ATTACHMENT A

PROJECT NAME: CITY OF SAN ANTONIO FIRE STATION NO. 21

This attachment shall be included in and considered part of the solicitation documents for the construction of the Fire Station #21 RFCSP 26-020 - Addendum I; consists of 2 pages and 27 pages of attachments.

8 ALTERNATE - SINK UNIT - ELEVATION
 SCALE: 1/12\"/>

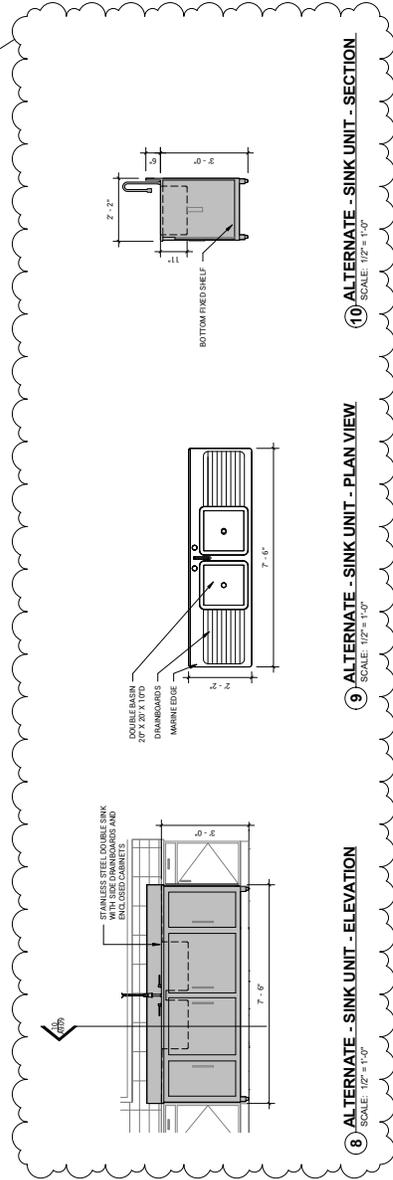
- Architecture
5. Sheet A9.03/5 Updated view
 6. Sheet A9.09/8 Added alternative option drawings for Stainless steel sink unit.

P2.01

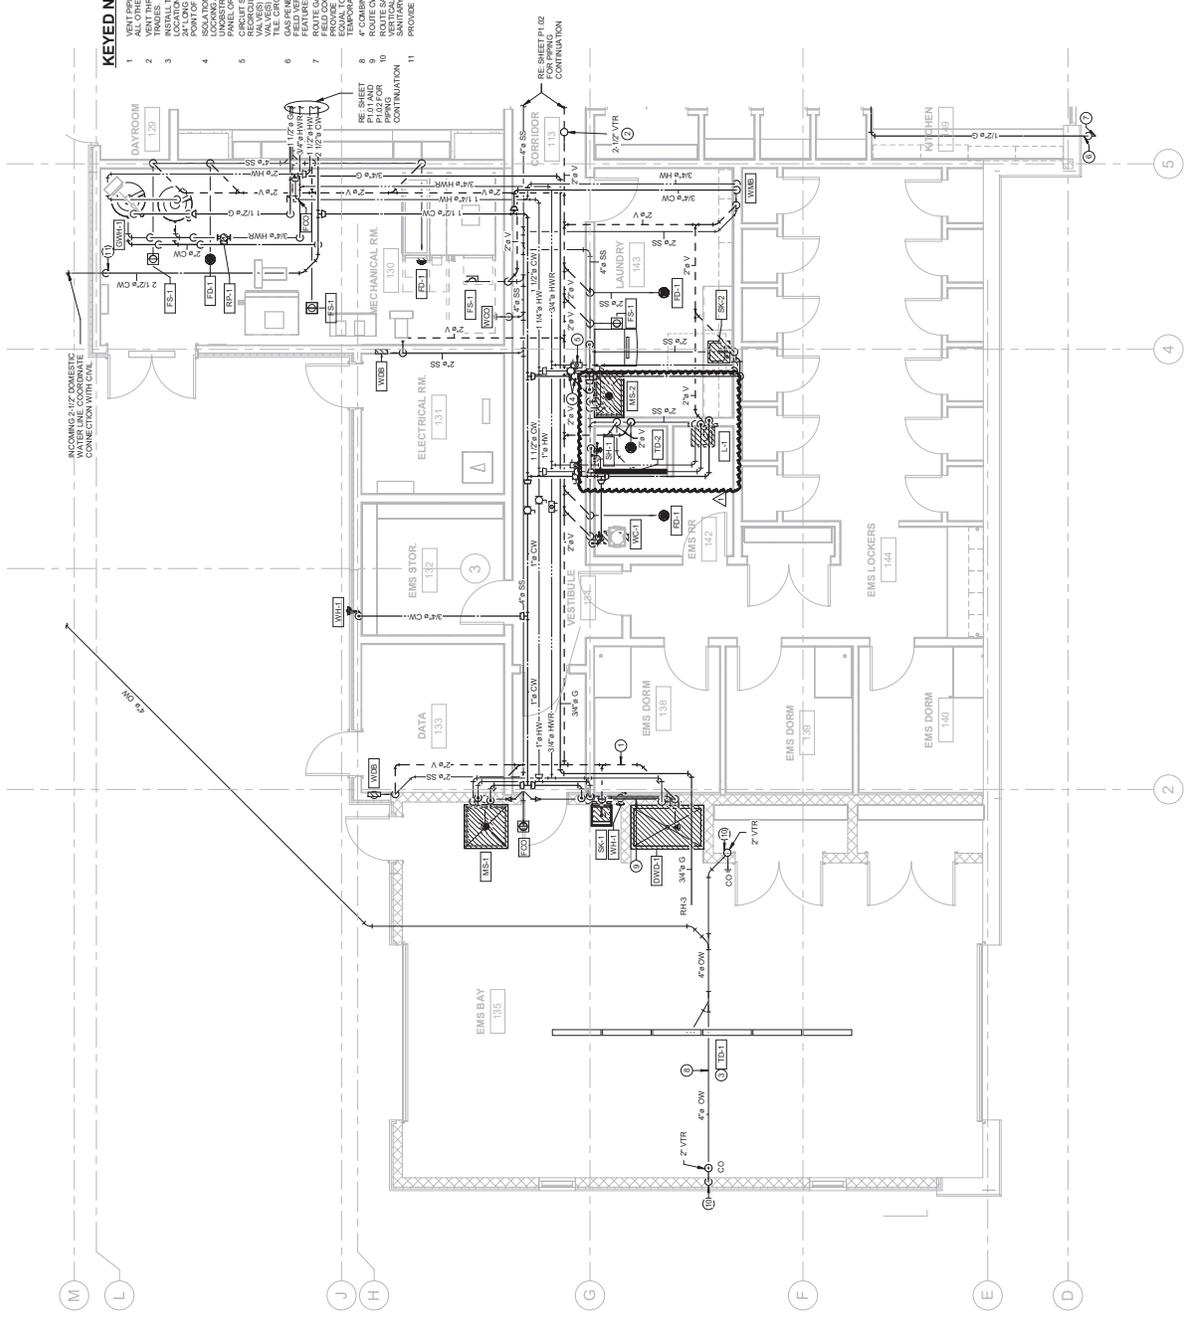
7. Sheet P2.01 Revised location of lavatory and shower in EMS restroom.
8. Sheet P3.01 Revised riser to reflect fixture changes in EMS restroom.
9. Sheet P3.03 Revised riser to reflect fixture changes in EMS restroom.
10. Sheet P4.01 Revised specification for SK-3 in Plumbing Fixture Schedule.

1 TECHNOLOGY SPECIAL SYSTEMS OVERALL FLOOR PLAN
 1/8" = 1'-0"

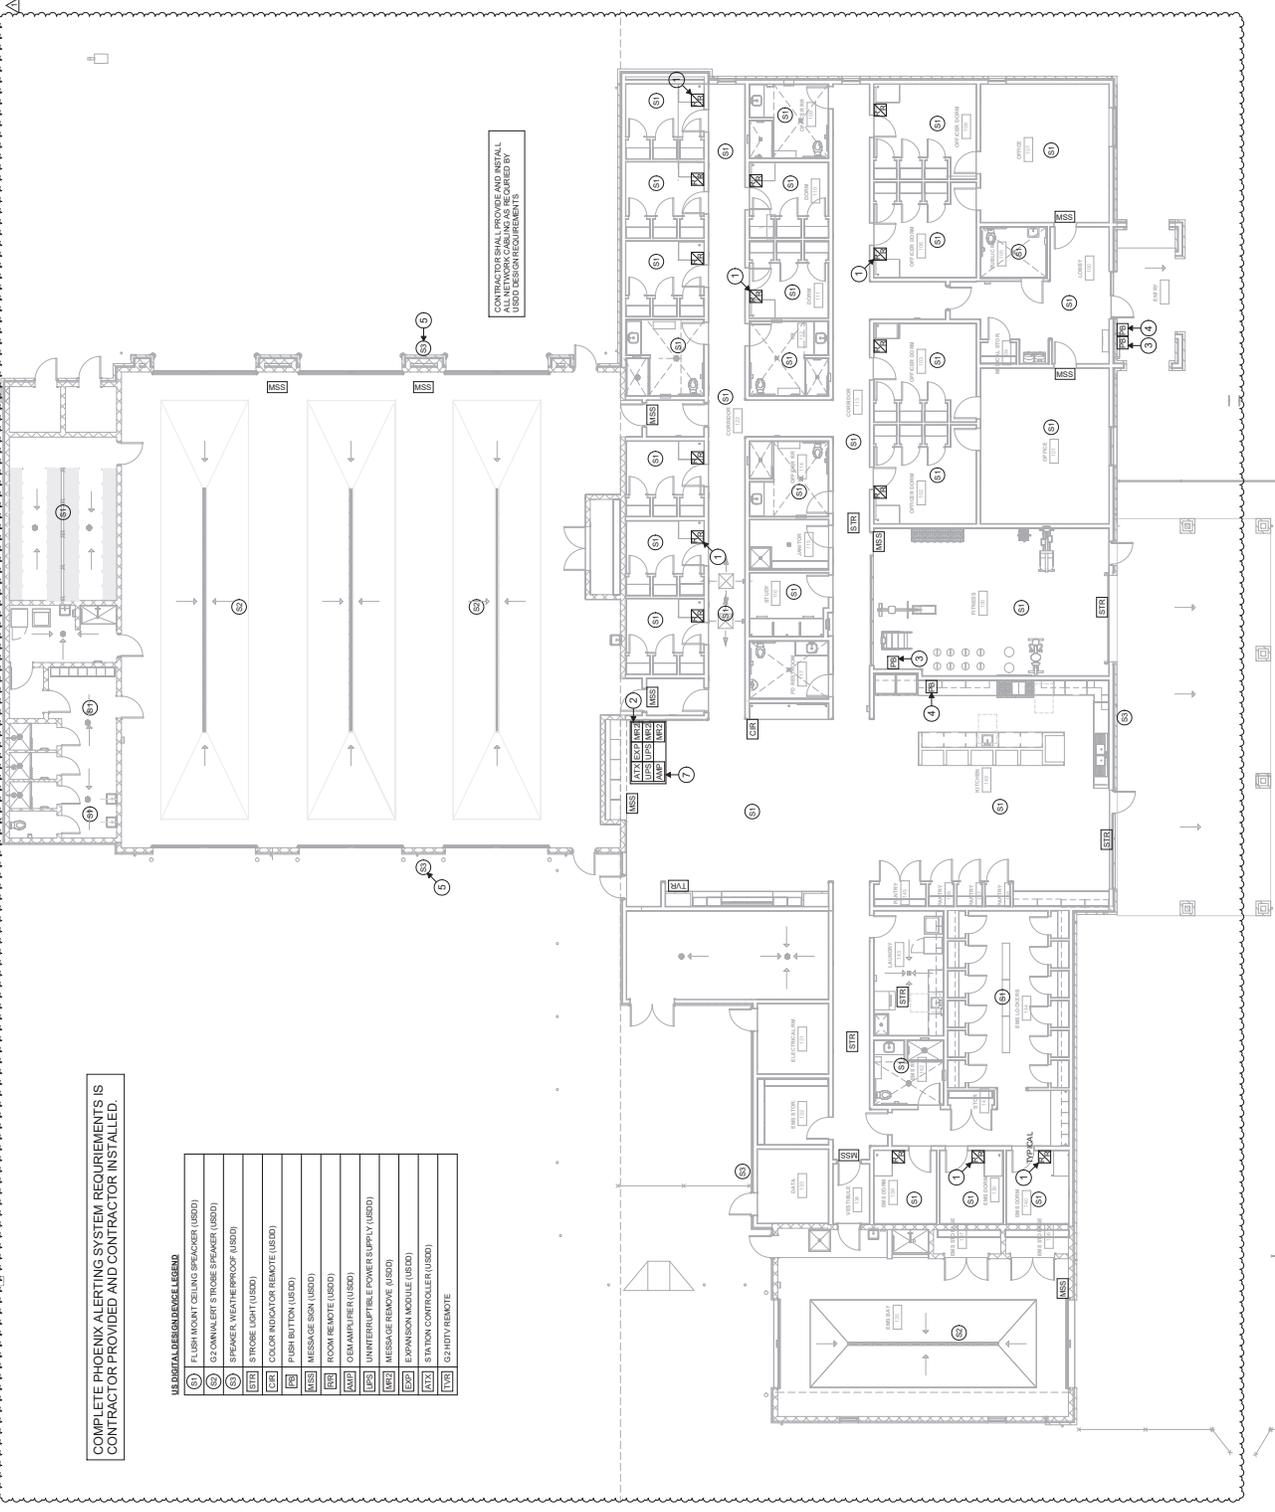
11. Sheet T600 Revised special systems device rough-in locations for the USDD system based on their latest changes with owner feedback. Refer to USDD drawings for additional information.
12. Sheet T601 Replaced sheet with the latest design layout received for the owner's design vendor, US Digital Designs (USDD), for the Phoenix G2 System.
13. Sheet T602 Replaced sheet with the latest design layout received for the owner's design vendor, US Digital Designs (USDD), for the Phoenix G2 System.
